ARKANSAS STATE HIGHWAY AND TRANSPORTATION DEPARTMENT

MEMORANDUM

TO: Mr. Veral Pinkerton, Bridge Engineer
FROM: W. E. Tyler, District Engineer, District No. 3
SUBJECT: BRIDGE CAP CONSTRUCTION

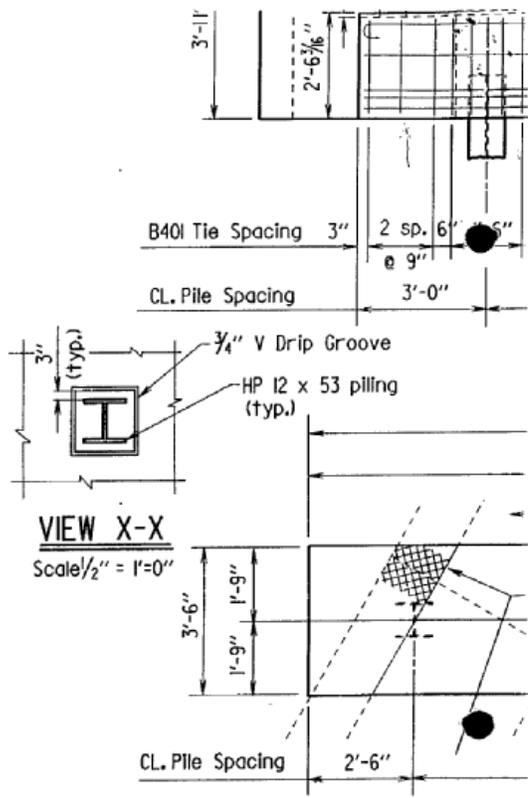
We have found in many of our bridge inspections that steel pilings are showing deterioration where they are connected to the cap. It appears that water is draining down the cap, under the cap, and collecting at the junction of the cap and steel piling.

It is suggested that a drip groove be constructed on the bottom of the cap between the edge of the cap and the piling.

This could possibly reduce the deterioration.

Handwritten: Let's try this! VP
